Addendum No. 1

STEAD MAIN REPLACEMENT PHASE 2

PWP No.: WA-2017-040
TMWA Project No.: 10-0001.030

December 21, 2016

D4

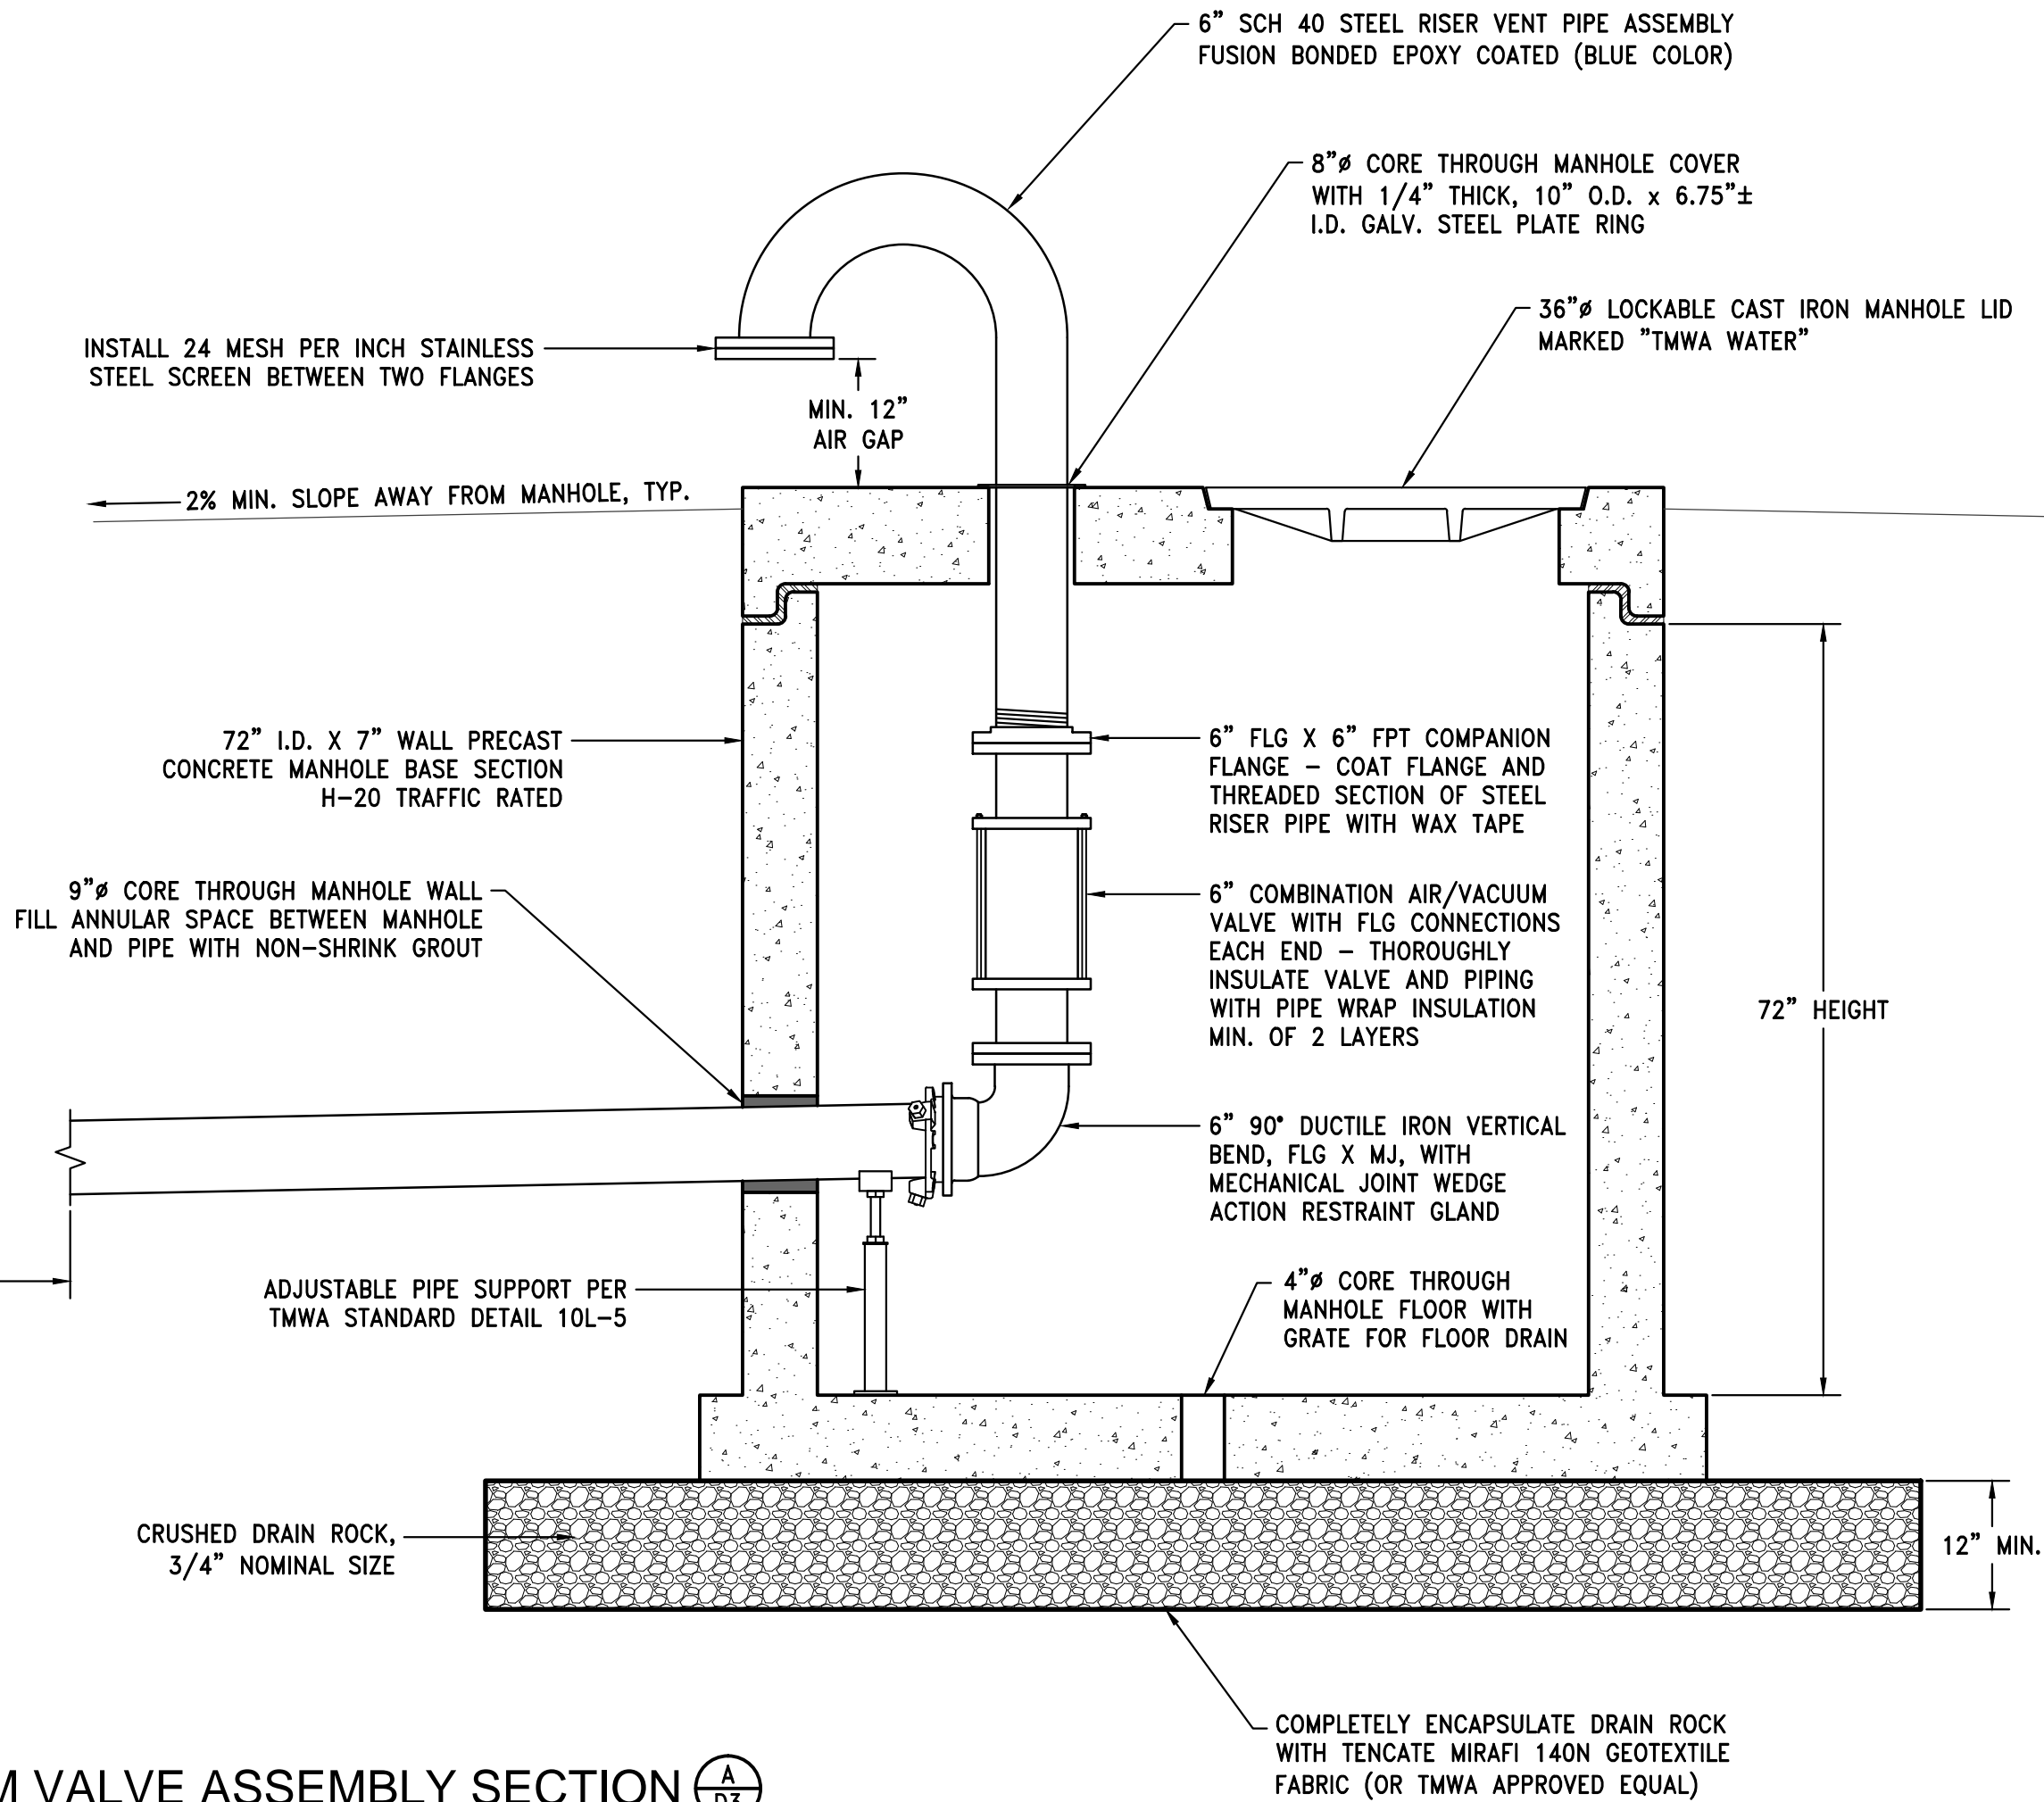
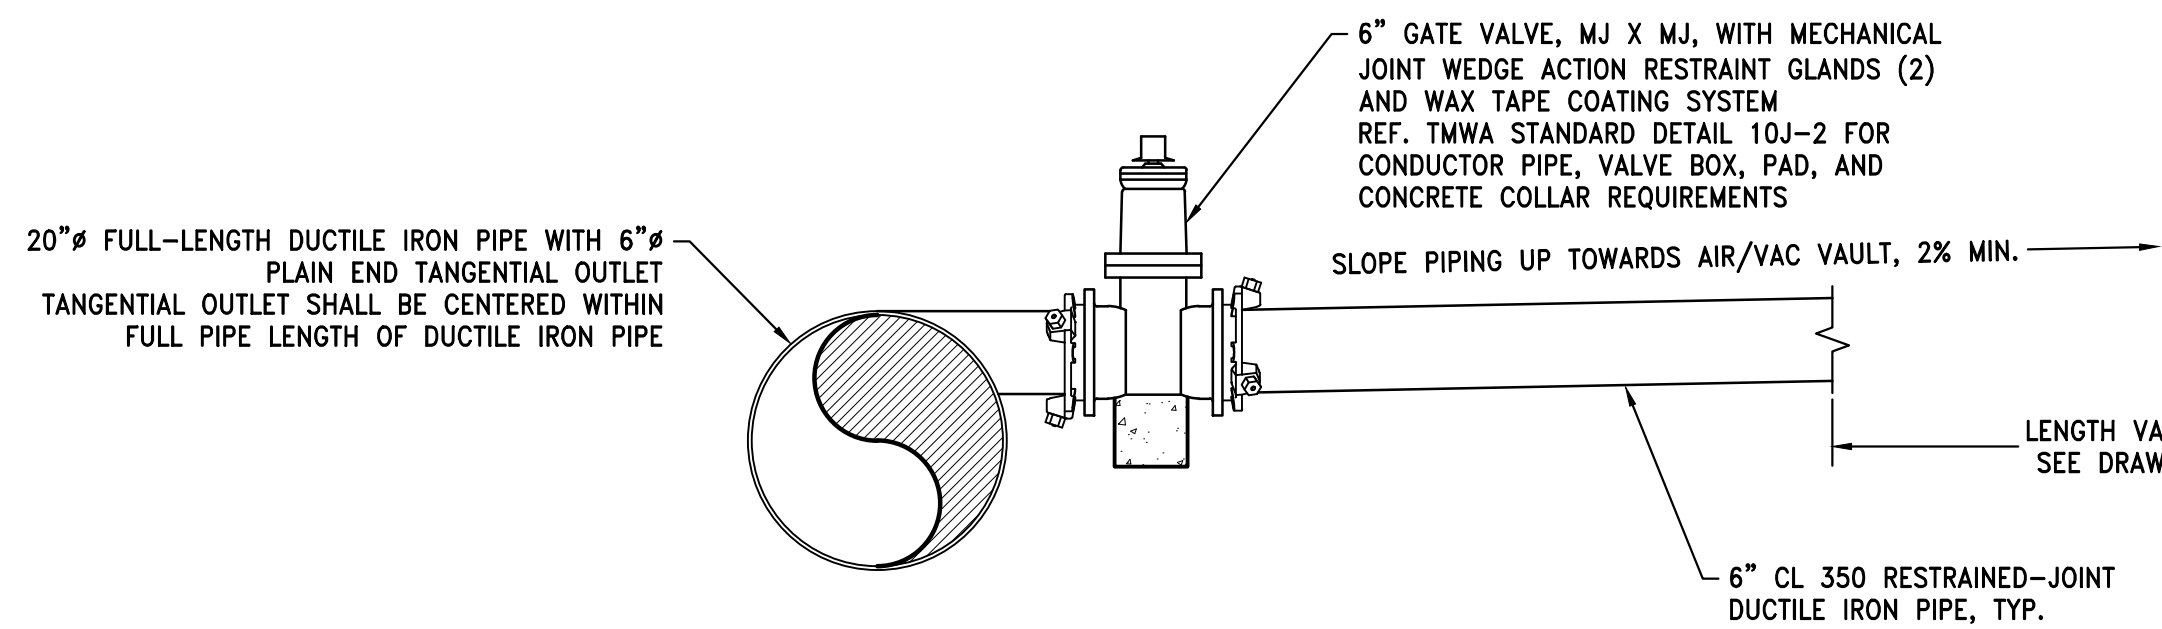
Drawing D4 (sheet 34) – added “MIN. 12” AIR GAP” dimension in section view
